TITLE MOTOR PULLEYS			PIB NO. DK3052	
PRODUCT LINE:	TAPE DISK FORMATTER <input checked="" type="checkbox"/>	EQUIPMENT CHANGED 102636-02	MODEL SERIES AFFECTED D3000	EFFECTIVE DATE April 30, 1976
CLASS OF BULLETIN: <input type="checkbox"/> IMPROVEMENT <input checked="" type="checkbox"/> RETROFIT ON FAILURE <input type="checkbox"/> RETROFIT RECOMMENDED <input type="checkbox"/> SERVICE INFORMATION ONLY		ORDER PART KIT NO. DK3052	EFFECTIVITY D3XX2 (60 Hz) D3XX1 (50 Hz) in serial number range 35XXXXXXXX, 45XXXXXXXX and 16XXXXXXXX	
<b>PURPOSE</b> <p>This bulletin has been issued to pin-point a possible cause of mechanical noise in the D3000 Disk Drive. Some motor pulleys fitted to disk drives assembled during the period July/December 1975 may become loose on the motor shaft after a period of satisfactory running. Further tightening of the set screws provides relief from the problem, but should only be considered a short term fix. A replacement pulley and set screws should be installed for a permanent solution.</p> <p>The pulleys which have demonstrated the problem are among those used on 2400 rpm, 60 Hz and 1500 rpm, 50 Hz drives and have the part number 102636-02 cast into the material.<

FIGURE 1, BELT THREADING PATTERN

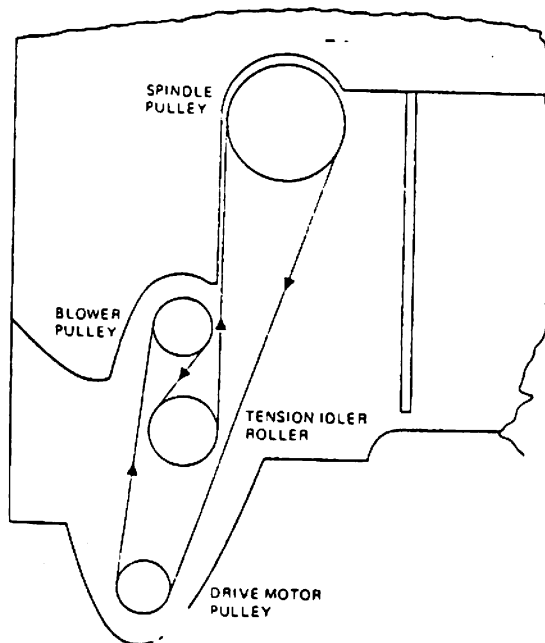
<b>SPECIAL TOOLS</b> None				
<b>PARTS REQUIRED</b> Replacement pulley part number 102636-02.				
<b>REPLACEMENT PROCEDURE</b> 1.0 <u>Belt Removal</u> Location of pulleys and direction of rotation is indicated in Figure 1. To remove the belt, proceed as follows: <ol style="list-style-type: none"><li>1. Remove three No. 10 machine screws securing the belt guard in place.</li><li>2. Slide the belt guard forward until it drops away from the base.</li><li>3. Insert a large shanked screwdriver between the tension idler plate and the base. Compress the tension idler spring until the belt is released from the motor pulley.</li><li>4. Remove the belt from area.</li></ol>

1. Locate the motor pulley as shown in Figure 1.
2. Loosen the two set screws.
3. Remove faulty pulley.
4. Install the replacement pulley.
5. Line up pulley with end of motor shaft.
6. Tighten set screws.

The following sequence is followed when replacing the drive belt. Refer to Figure 1 for threading pattern.

1. Loop one end of drive belt around spindle pulley. Center the belt on crown of pulley and, by hand, hold the remainder of belt taut until step (2) is completed.
2. Feed the remainder of the belt loop under the idler tension roller arm.

3. Feed the remainder of the belt loop again under the tension roller arm and up toward the blower pulley.

4. Loop the belt around the blower pulley. Release the loop and extend the remainder of the belt loop to the drive motor pulley.
